Additional Information (Ownership Maps)

Scorpion Oil & Gas, LLC
BC Dickenson D No.5
(SWD-2614)

APPLICATION FOR AUTHORIZATION TO INJECT

Leaseholder map

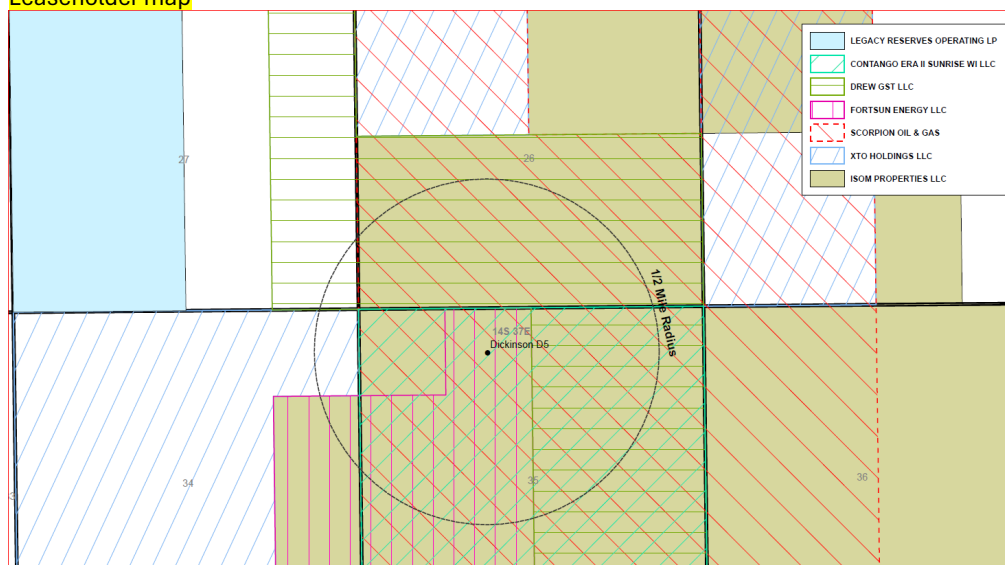
1. The Leaseholder map indicates multiple lease owners within the half-mile AOR (see snapshot below)
 - a. Scorpion's application lists only **Stephens Engineering** as being notified as per the C-108 "Proof of Notice" Requirement
 - i. As per the C-108 Section XIV (see below). All leaseholders within ½ mile must be notified.
 - ii. IF my interpretation of your leaseholder map is correct, none of the leaseholders were notified?
 - iii. Please provide documentation to confirm that all C-108 notice requirements have been satisfied.
2. None of the pdf images contain a label to identify the content of the map ie. Mineral owners, lease holders etc.
 - a. Since this information will be compiled into a document for the wellfile , please ensure all pdf images contain a label (not just a filename), to clearly identify what is being conveyed in each image.

Attachment 1. Dickinson D #5 two mile and half mile radius

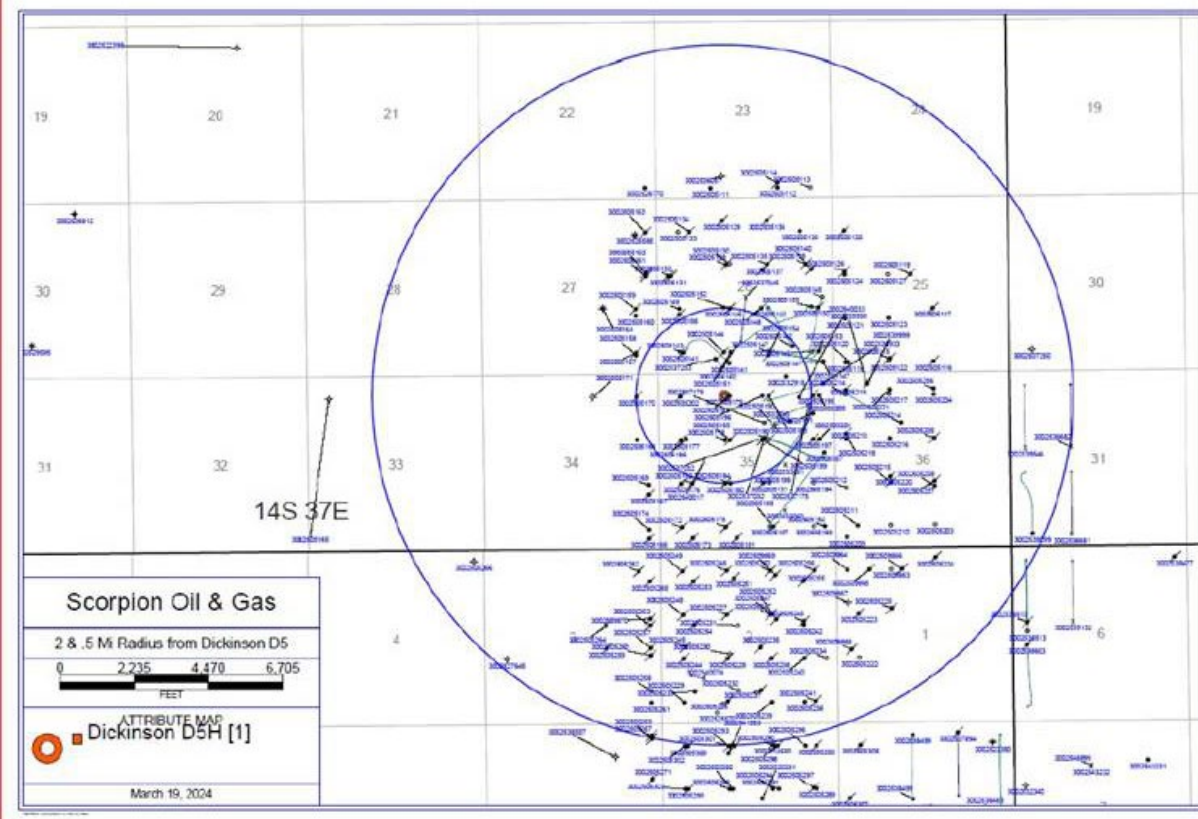
1. A map showing Surface ownership for the well location
2. A map showing Lease ownership with the ½ mile Area of Review (AOR)
3. A map showing Mineral Ownership within the ½ mile AOR
4. A map showing water wells within a 1 mile AOR
5. A map showing clearer detail for all wells within the ½ mile AOR (See snapshot below from Attachment 1 of your application).
